# 7903 GREENWOOD AVE N

EARLY DESIGN GUIDANCE RESPONSES

ADMINISTRATIVE DESIGN REVIEW  
MAY 29, 2020 #3032858-LU

A SECTION THROUGH SF-5000 PORTION OF LOT AND AMENITY DECKS

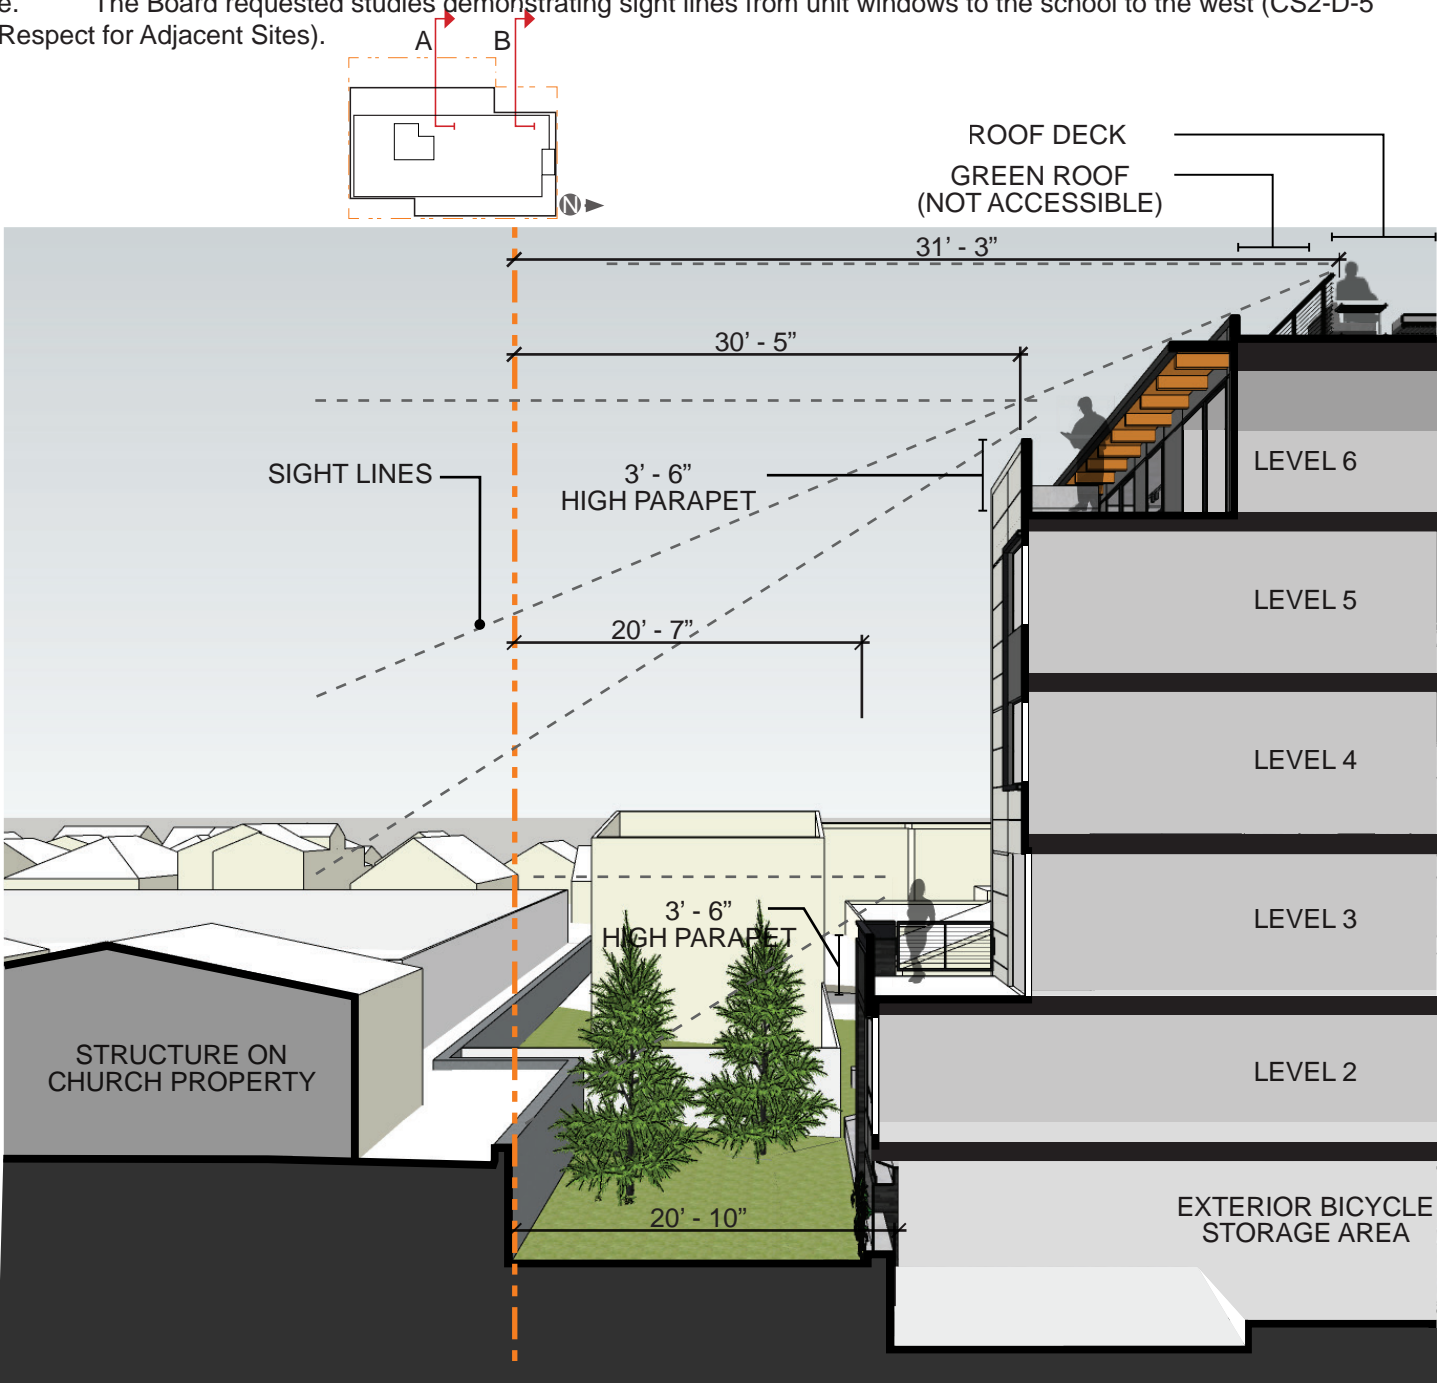
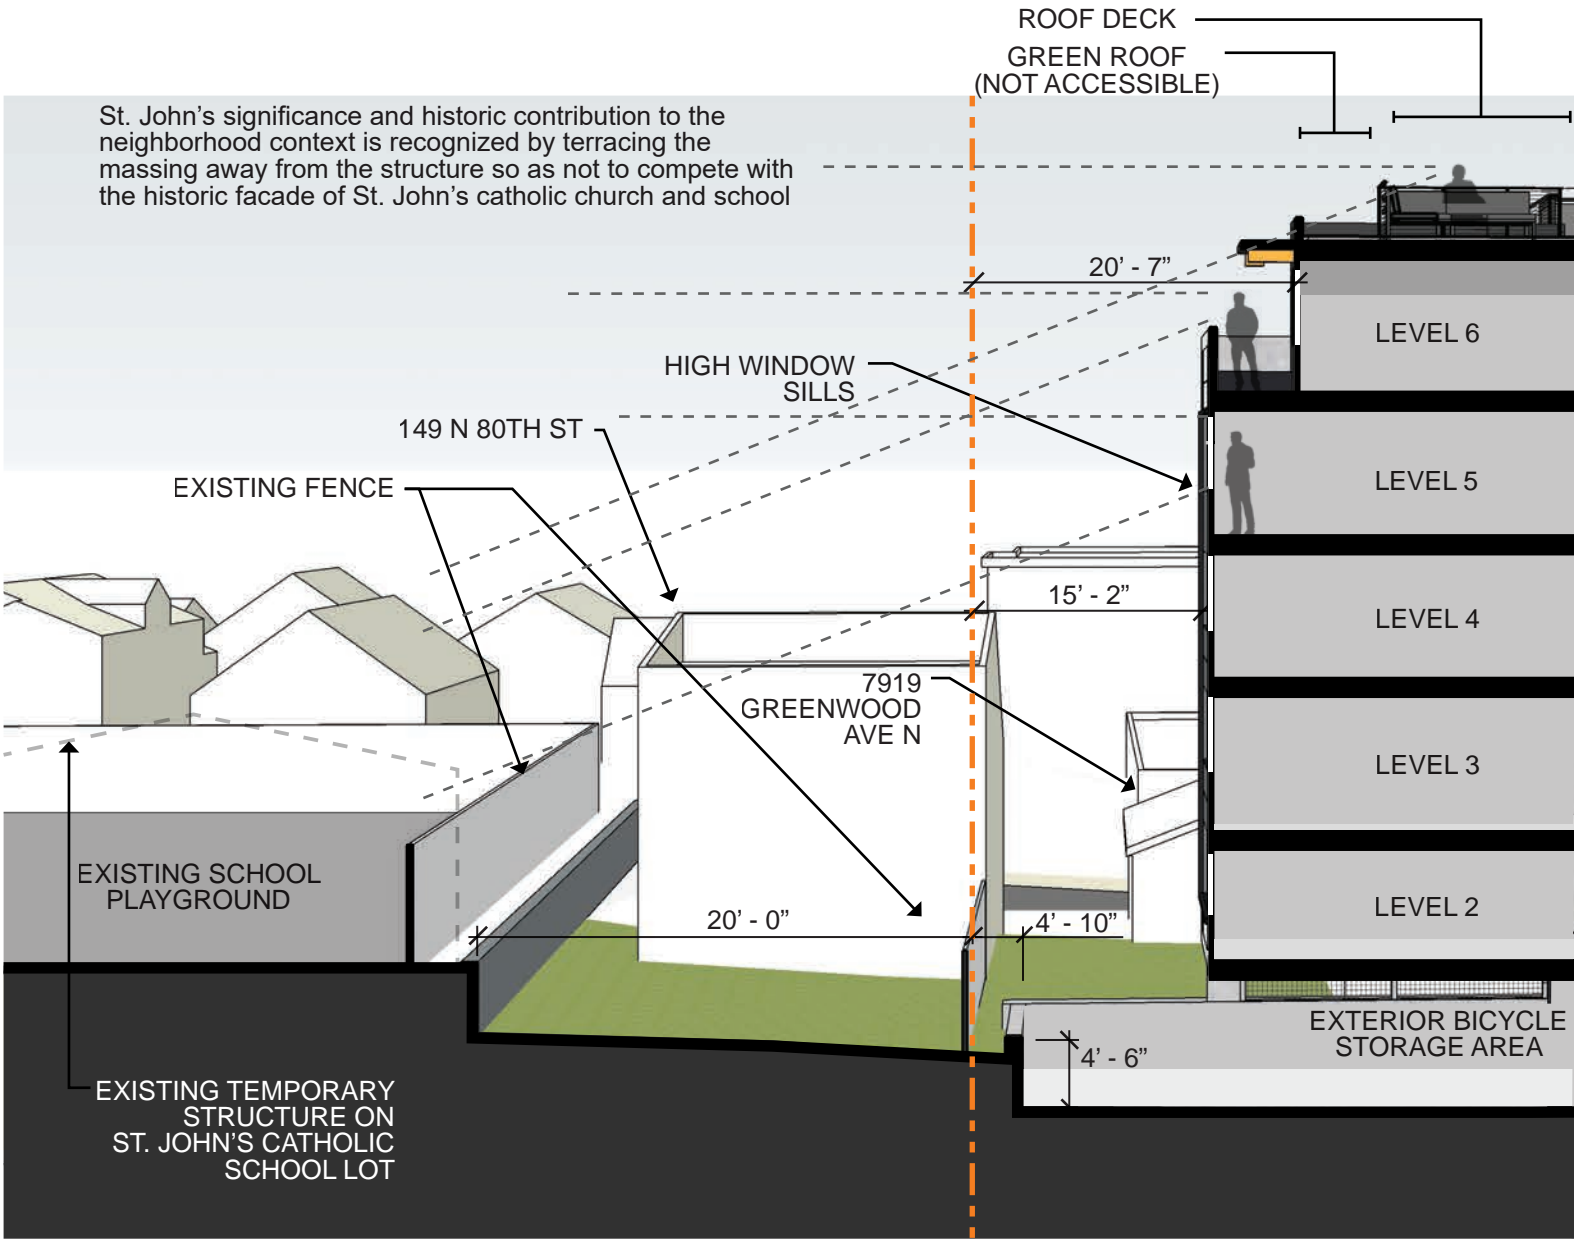
- 3) Landscape and Materiality:
- a. Privacy to the school abutting to the west was identified as a concern in public comment.
  - b. The Board acknowledged this concern and agreed the massing provided an appropriate transition and that materiality, secondary architectural features, and landscape design could further mitigate these concerns (CS2-D Height, Bulk, and Scale, CS2-D-5 Respect for Adjacent Sites).
  - c. For instance, the Board noted that the required 20-foot ground level setback along the west property line could be densely landscaped to provide privacy (CS2-D-5 Respect for Adjacent Sites).
  - d. Window location and any deck materiality should consider privacy to the adjacent school (CS2-D-5 Respect for Adjacent Sites).
  - e. The Board requested studies demonstrating sight lines from unit windows to the school to the west (CS2-D-5 Respect for Adjacent Sites).

- a. - d. The proposed design maximizes privacy from the abutting school by modifying the west façade fenestration patterns, providing solid partial height deck walls at the west facing amenity decks, and using the generous setback to provide landscaping as an additional buffer. The west facing windows are designed to maximize privacy by having elevated window sills, restricting lower sightlines from the units while maintaining wider window widths to maximize natural light to the units. Where the building sets back at levels three and six, partial height solid walls further restrict sight lines down on the adjacent school property. At grade the building sets back 20' from the west property line, providing an additional buffer between the proposed building and school. The SF-5000 portion of the lot will not be developed under this permit and will remain as native grade. However, the project could benefit from planted trees and landscape in this 20' wide portion of the lot to further increase privacy between the structure and adjacent property.

- The setbacks at levels three and six proposed at the early design guidance meeting and supported by the board have been maintained to create an appropriate transition between the project and adjacent property.

- e. A privacy study illustrating the sight lines to the west from the building unit windows to the school is provided on this page.
